# Service Bulletin

Bulletin No.: 23-NA-106

**Subject: Floor Console Armrest Lower Panel Separating**

Brand:	Model:	Model Year:		VIN:		Engine:	Transmission:
		from	to	from	to		
Cadillac	LYRIQ	2023	2023	—	—	All	All

6370321

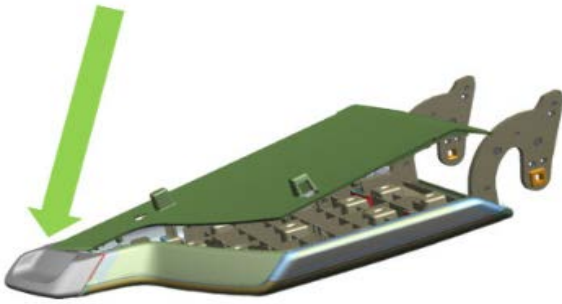
<b>Involved Region or Country</b>	North America
<b>Condition</b>	Some customers may comment that the upper lid of the console center armrest is separating from the lower section when trying to open.
<b>Cause</b>	The cause of the condition may be that in high temperatures, the retention force is insufficient to retain the panel when opening the armrest.
<b>Correction</b>	If you encounter a vehicle with the above concern, complete the Service Procedure outlined below.

1. Add 3M Scotch-Weld Structural Plastic Adhesive DP8010 adhesive (or equivalent) in the snap retention features at front of armrest lower panel shown above.

2. Reinstall the armrest lower panel at front edge per the illustration above and allow adhesive to dry per directions on packaging (10 minute work life with 60 minute handling strength).
